**PRELIMINARY DRAINAGE STUDY  
FOR  
MAVERIK INC. – SITE CODE CO-0258  
1-25 & COUNTY LINE ROAD  
MONUMENT, CO**

Add PCD File No.  
PPR-21-054

Jun 10, 2021

**MAVERIK GAS STATION**  
 MONUMENT, EL PASO COUNTY, CO  
**DRAINAGE CALCULATION EXHIBIT**

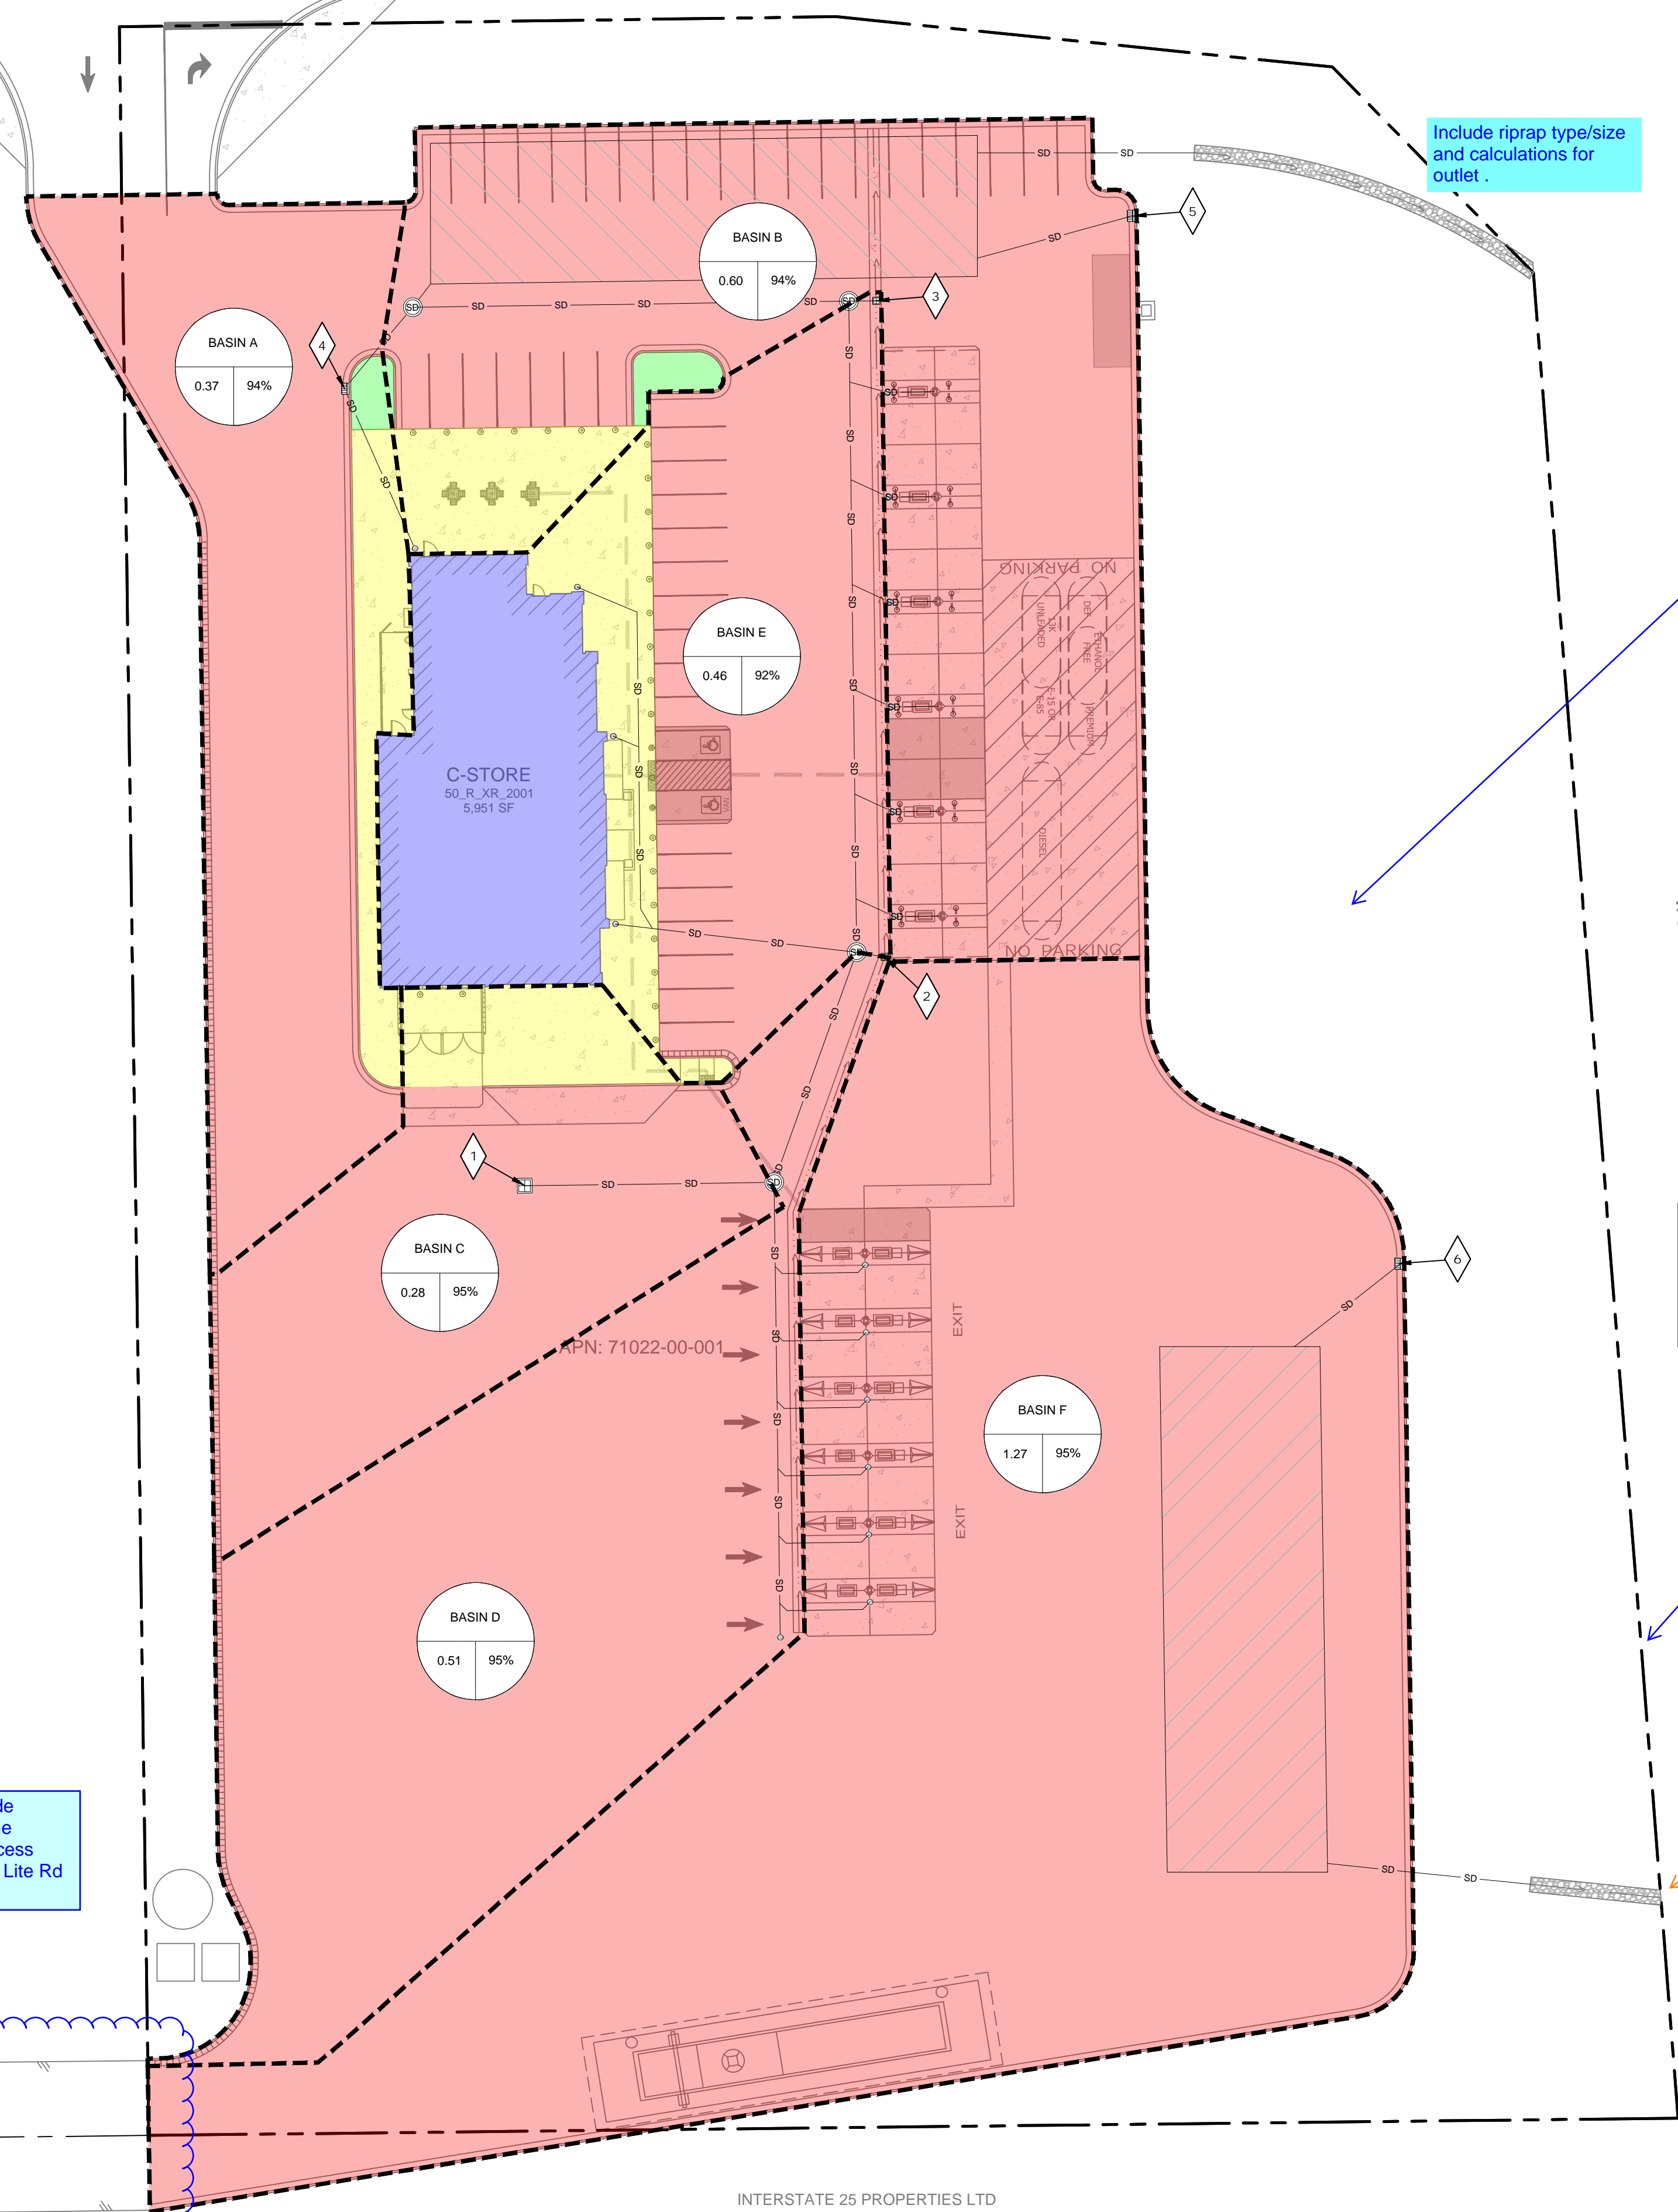
please place the drainage maps at the end of the report so that they are the last pages.

- Add existing and proposed grading.
- Include flow arrows.
- Label all high and low points.
- Label detention facilities
- Label all storm drain
- Include all linetypes & symbols used in legend
- Label all existing and proposed easements
- Expand map to west to include access connect at Beacon Light
- Include an existing drainage conditions map.

All land disturbance proposed shall be shown and addressed in the drainage report

Include riprap type/size and calculations for outlet .

Where does this area drain?

Include minor flows in basin table

Show ditch that UG detention facility will discharge into, as discussed on Page 7 above.

Label property boundary

Show suitable outfall and discuss in text above.

Include riprap type/size and calculations for outlet .

Please include analysis of the proposed access from Beacon Lite Rd to the site

-Show design point summary table

## Area-Weighting for Runoff Coefficient Calculation

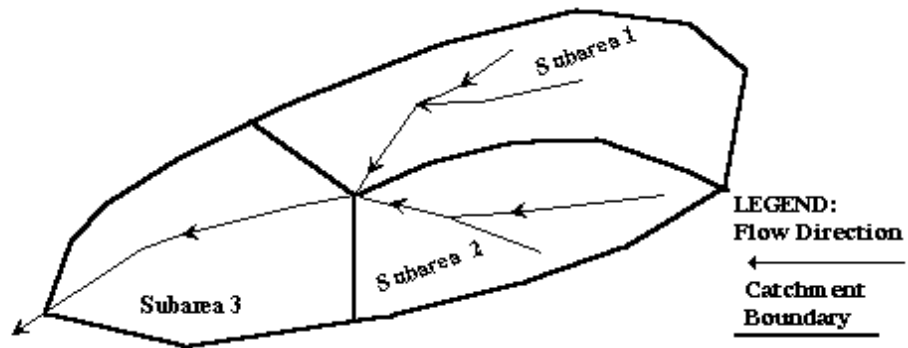
Include 'C' value corresponding to each % impervious

Report states project area is approximately 4.9 acres. where is additional 1.5 acres?
